### QUESTIONS & ANSWERS 001

This document is issued to answer questions from bidders regarding Innovation, Science and Economic Development Canada RFP # ISED206662. ALL TERMS AND CONDITIONS OF THE RFP REMAIN UNCHANGED.

Cat.6 - Item 26

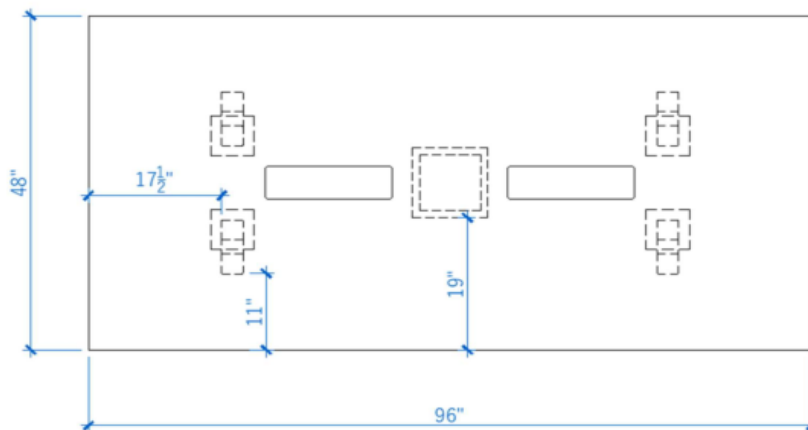
Referencing response Q15

Medium Rectangular Meeting Table:

As requested, below is a sketch of a 'Post Legs with Column' base type table, which matches the GoCUID 6MMTMDREOL48L96WYNX.

Yes, ISED accepts this table as it follows the requirements.
